MEMORANDUM

Date: September 26, 2018

Re: Requested design alterations and additional information for the Sugar House Heights
Planned Development and Preliminary Subdivision at 2660 S. Highland Drive / Petition
#PLNSUB2017-01027 & PLNSUB2017-01028

SHEET No.
A2.0-L1

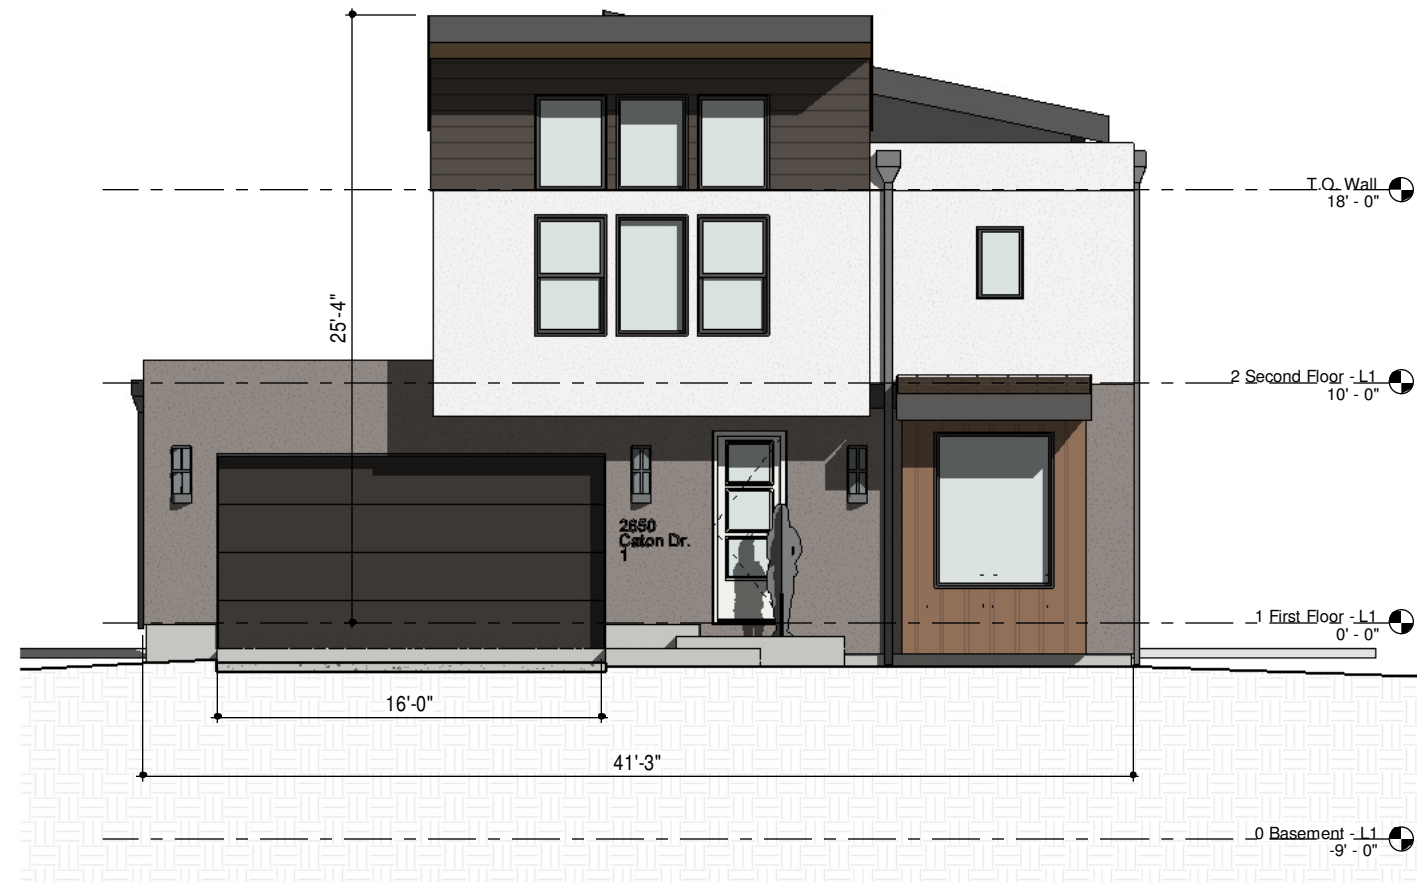
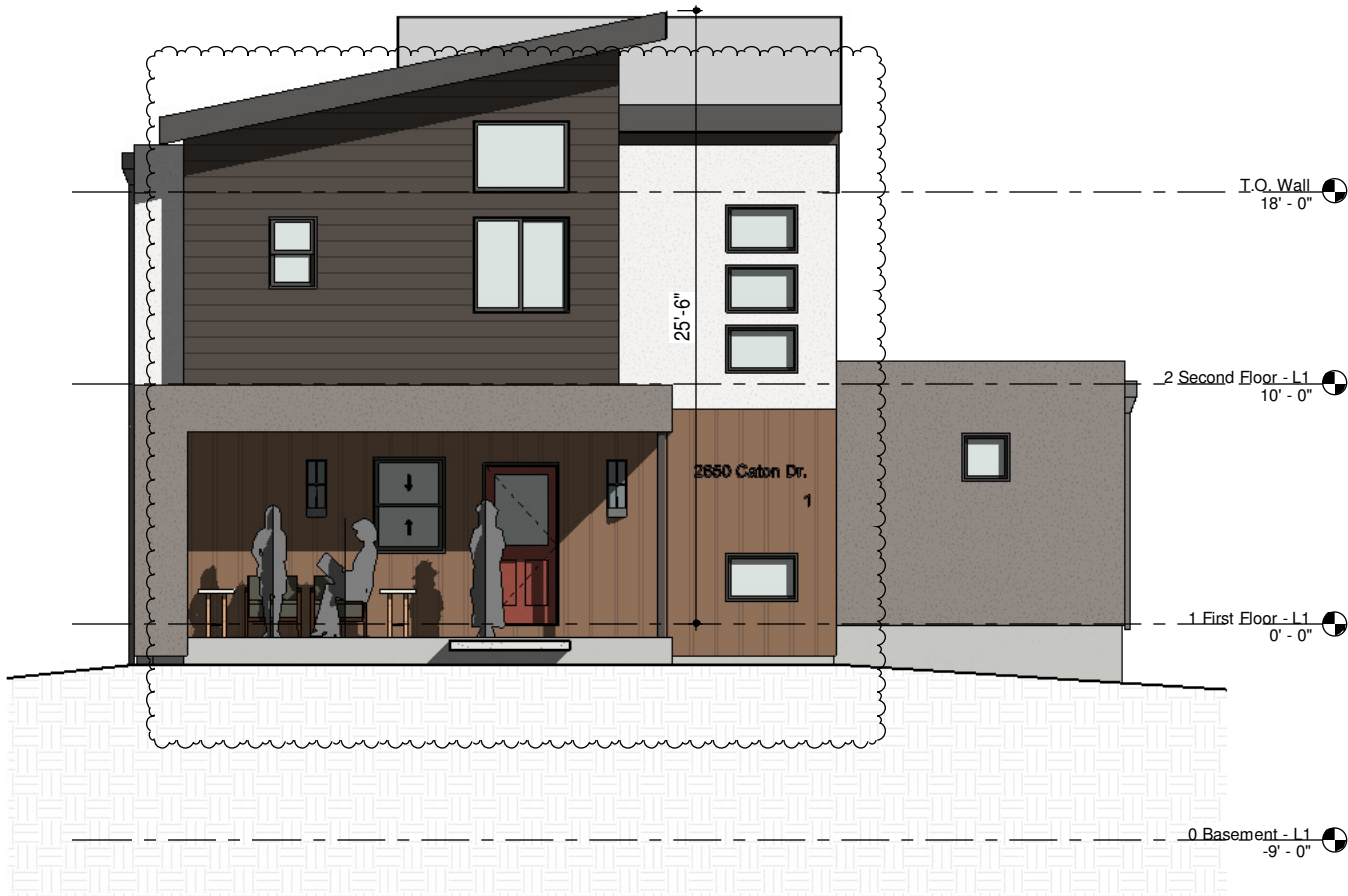
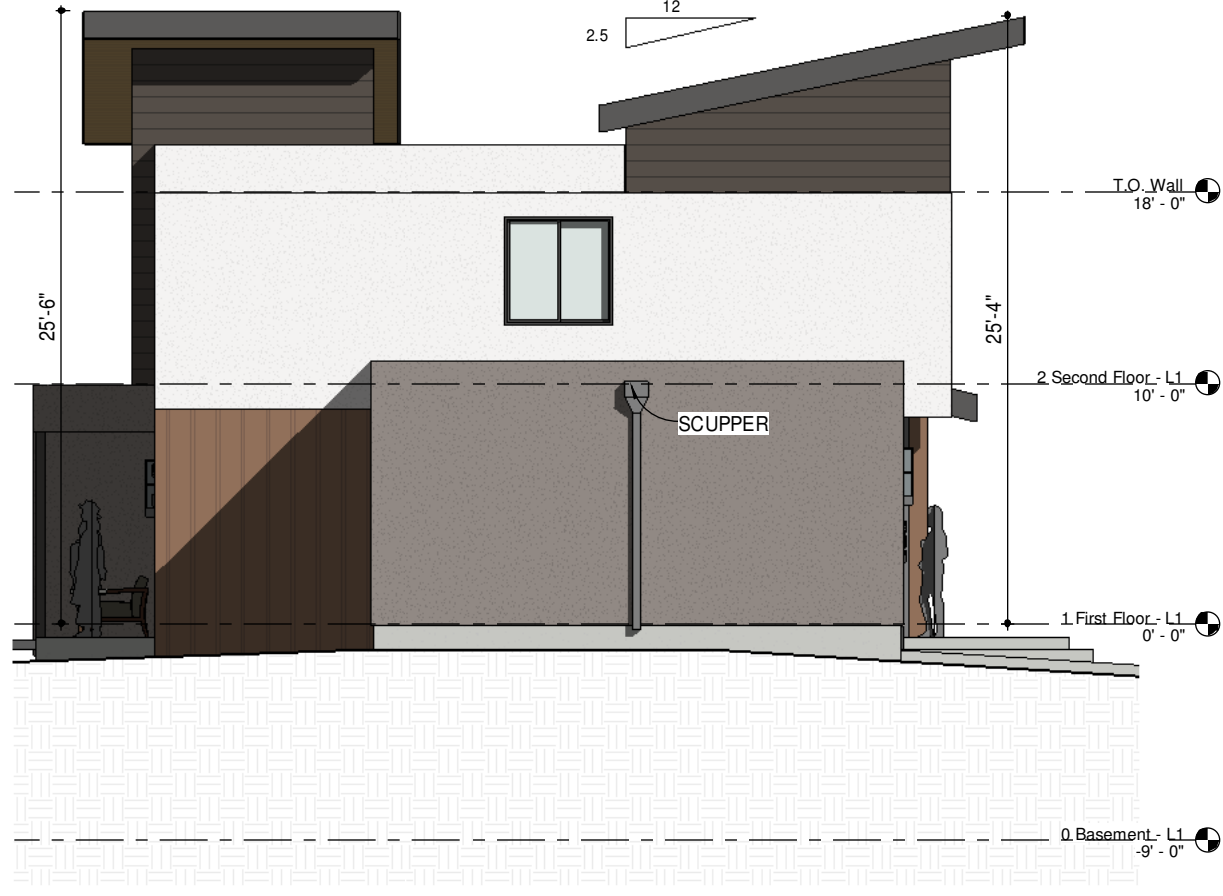
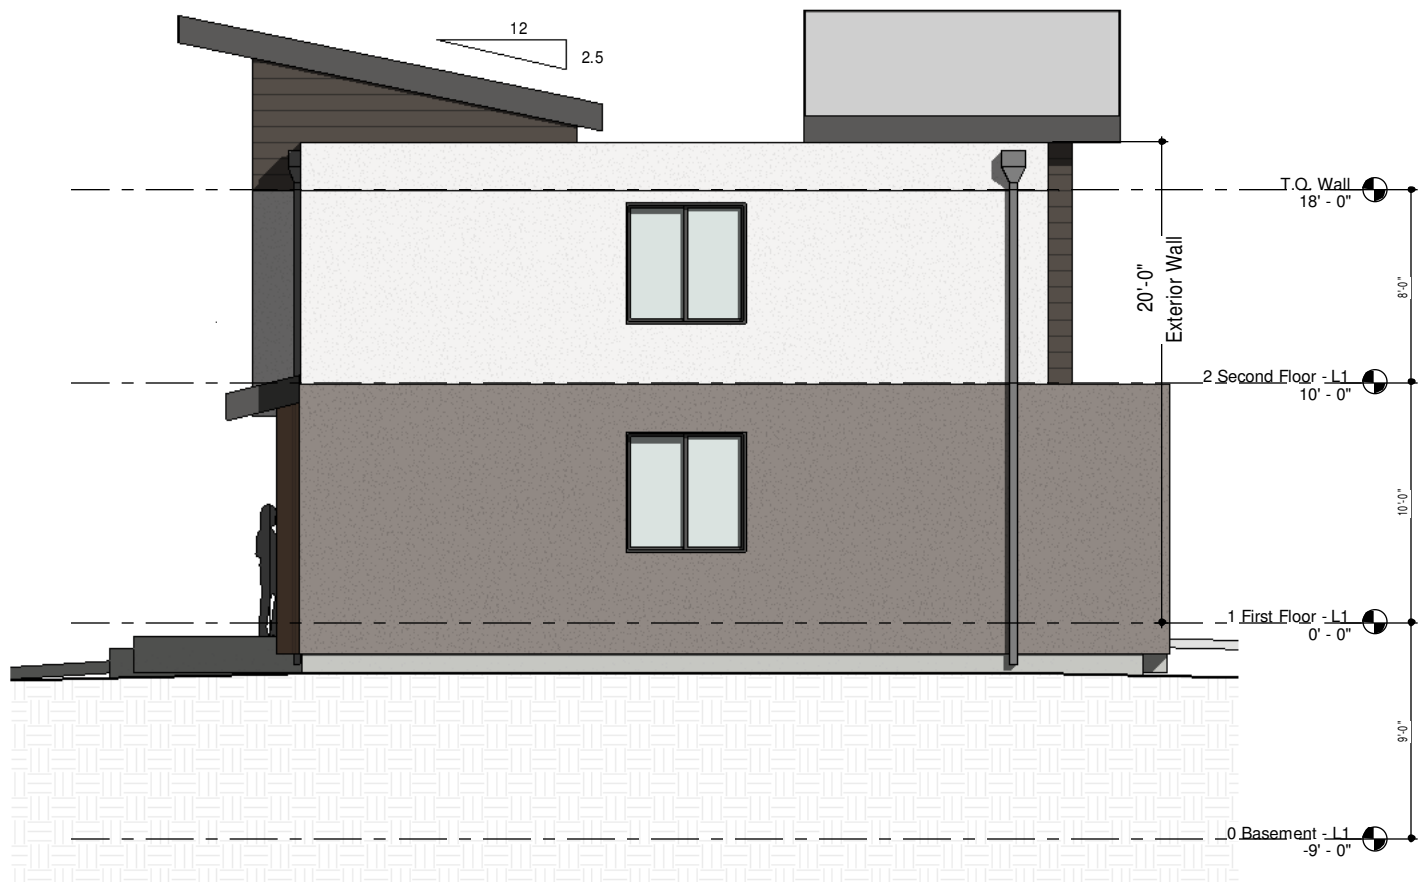
To ensure compatibility with the character of existing development within the vicinity of the site, the eastern elevations on the homes of lots 1 and 2 (that face Highland Drive) shall be altered to include architectural features typically found on the front façade of a single family home, such as:

- a. Enhanced entryways with useable porch features;*
- b. Prominent front entry doors;*
- c. Window patterns/configurations that are more appropriate for a prominent, street-facing façade;*
- d. Use of more articulation in the building wall and/or additional building materials to increase visual interest.*
- e. Roof detailing that would be more consistent with the front of a home;*

Lot 1 – Eastern elevation with frontage on Highland Drive

- Added a pitched roof form
- Added a semi-enclosed porch with slab on grade
- Altered window configuration
- Increased use of wood siding
- Added lighting fixtures

A2.0-L2

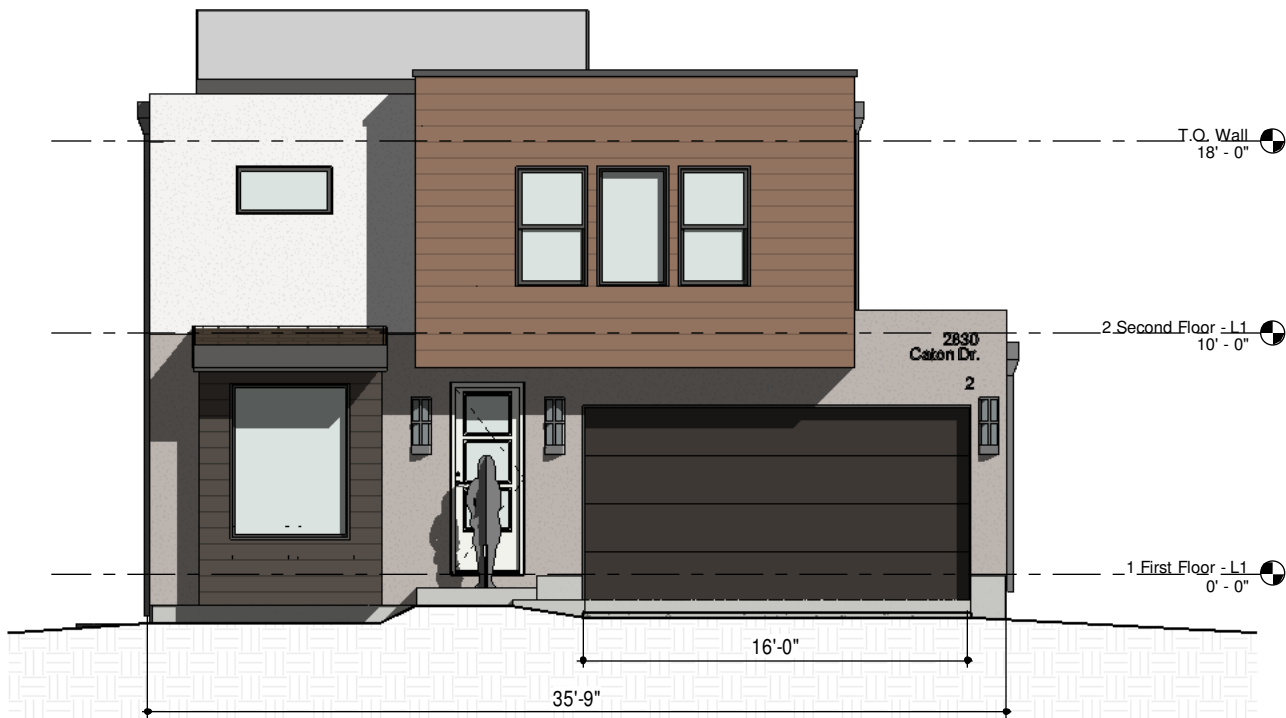
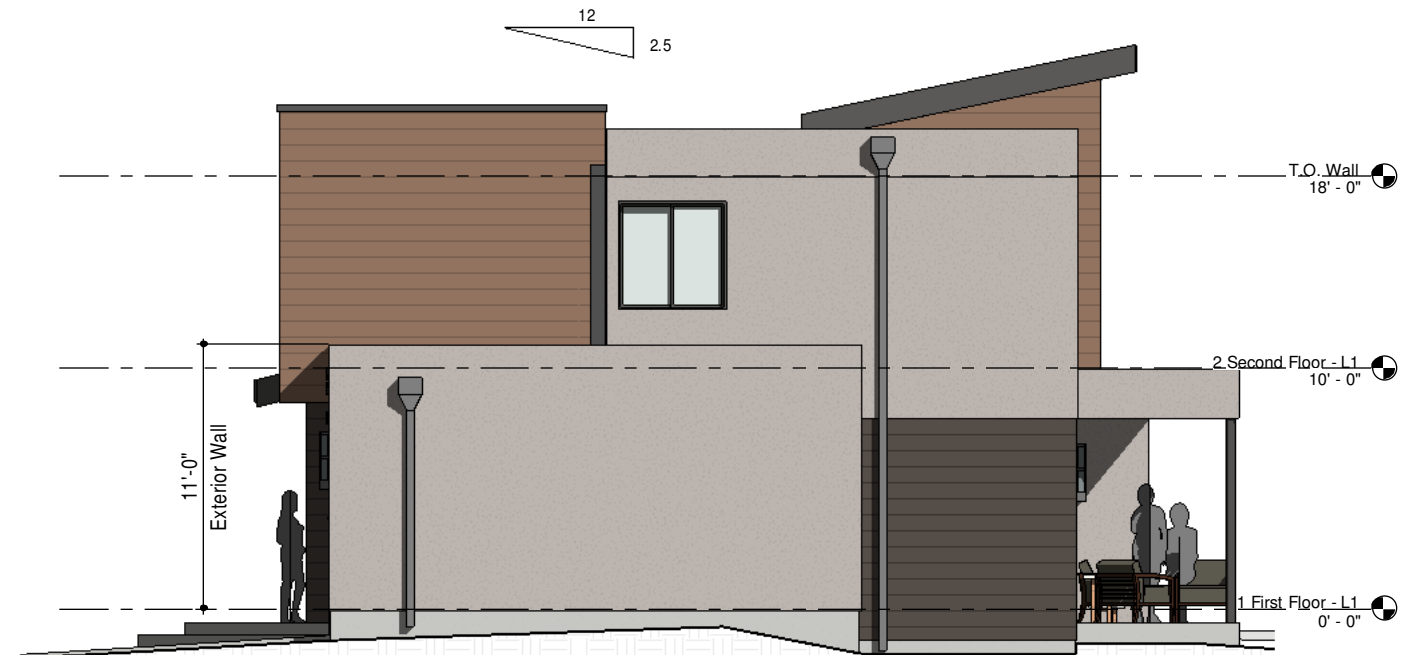
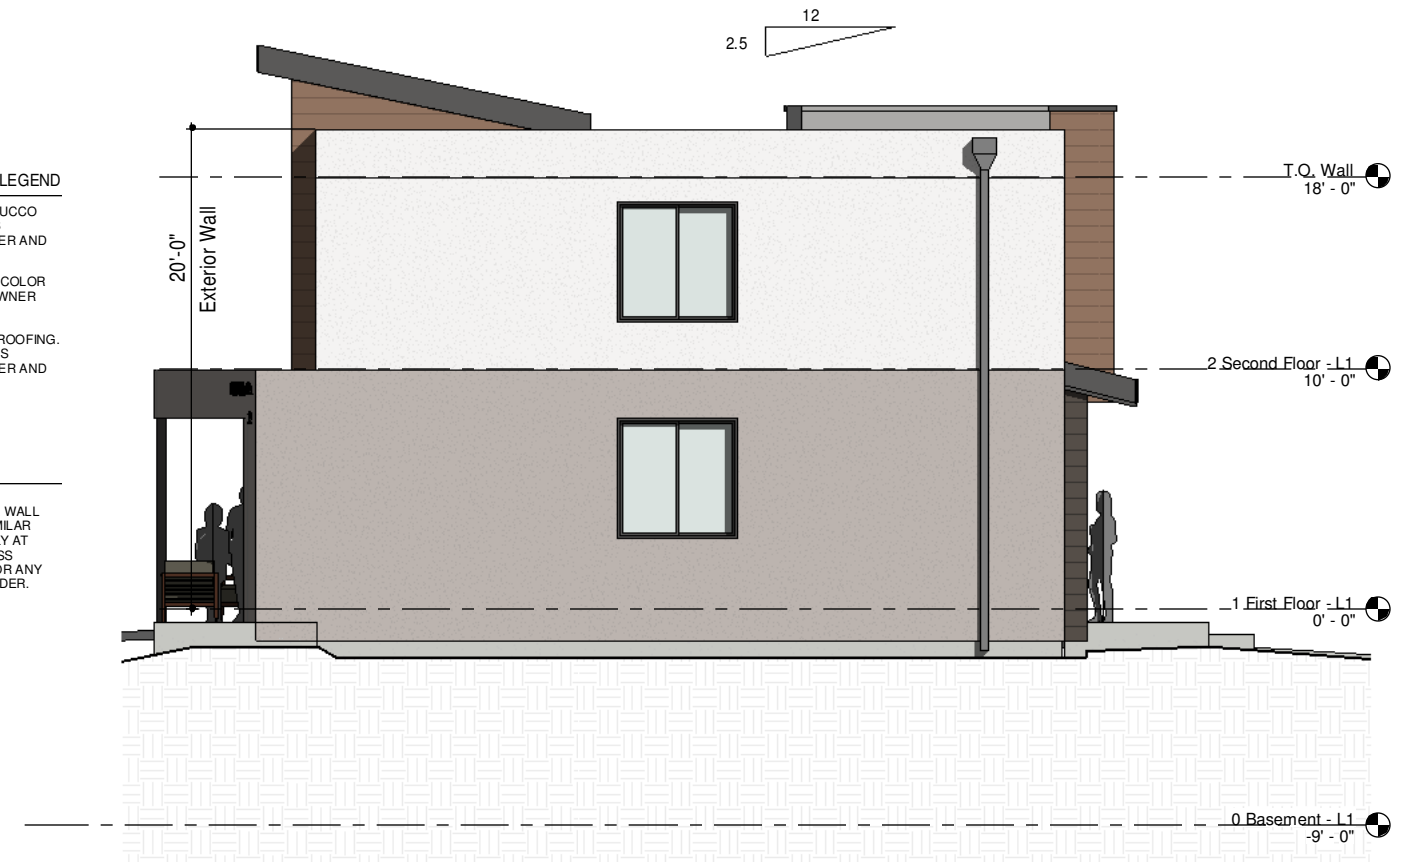
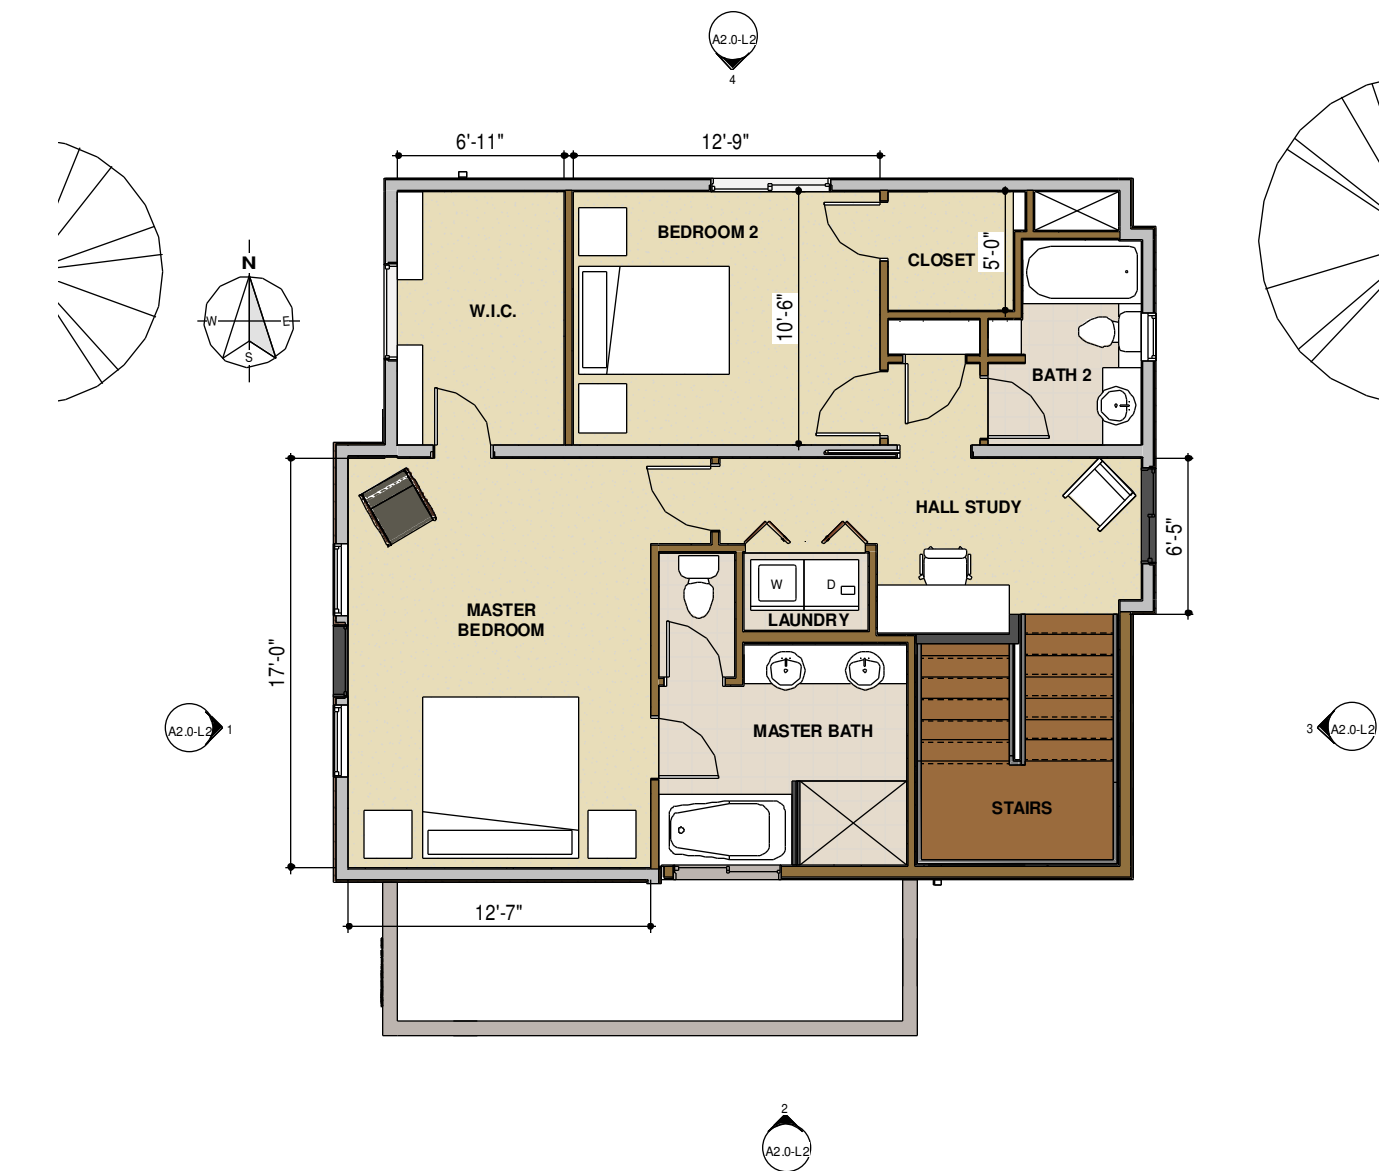
Lot 2 – Eastern elevation with frontage on Highland Drive

- Added a pitched roof form
- Added a semi-enclosed porch with slab on grade
- Altered window configuration
- Increased use of wood siding
- Added lighting fixtures
